Moriah College,
Redevelopment - Queens
Park Road, Queens Park

**Access Review –
Final v1**

04 October 2019

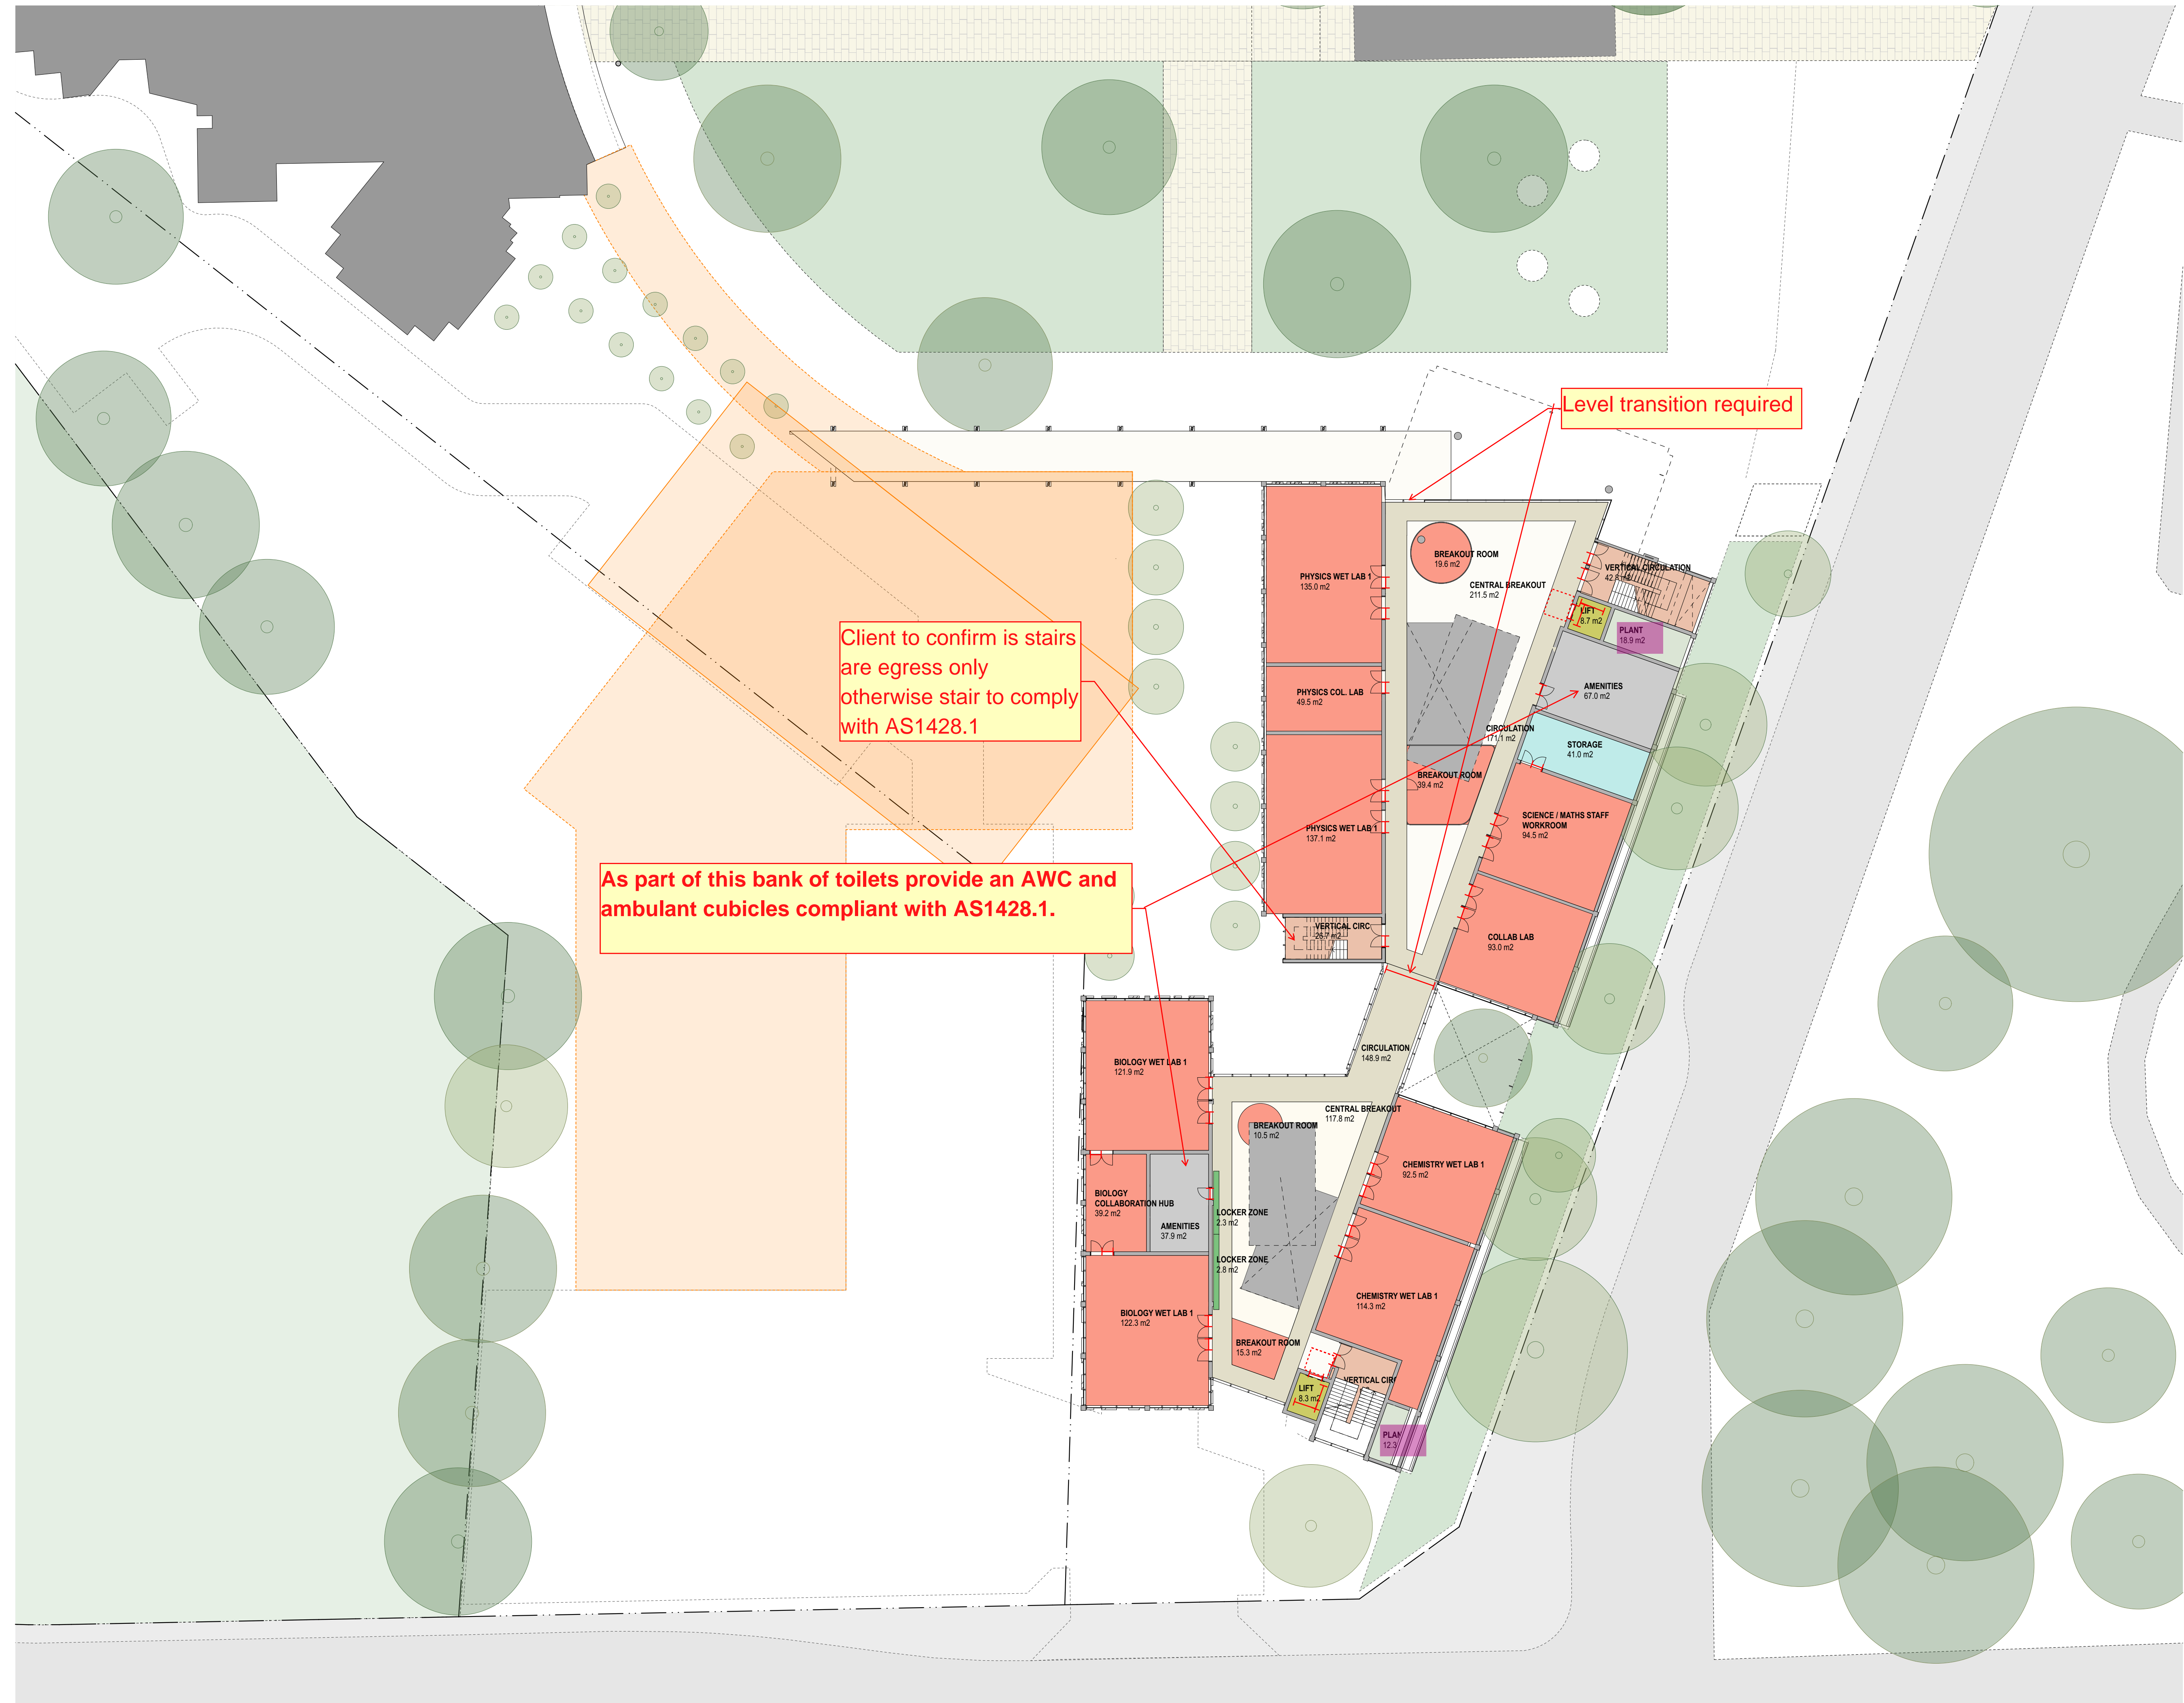
**Exempt under
BCA D3.4. TBC by PCA on
further stage**

**Allow space for
compliant TGSi and
handrail extensions**

Staff non-accessible storage exemption to be confirm by PCA consultant on a further stage.

As part of this bank of toilets provide an AWC compliant with AS1428.1.

BASEMENT PARKING
25 SPACES
6 ACCESSIBLE SPACE
= TOTAL 31 SPACE

Counter to comply with DDA Requirements

Client to confirm is stairs are egress only otherwise stair to comply with AS1428.1

As part of this bank of toilets provide an ambulant cubicle compliant with AS1428.1

It is recommended to move accessible car parking closer to the ramp landing, Ensure compliant path of travel from accessible carpark to the ramp

Ensure ramp in no more than 3.6m height.

Level transition required

Provide suitable latch side clearance according AS1428.1
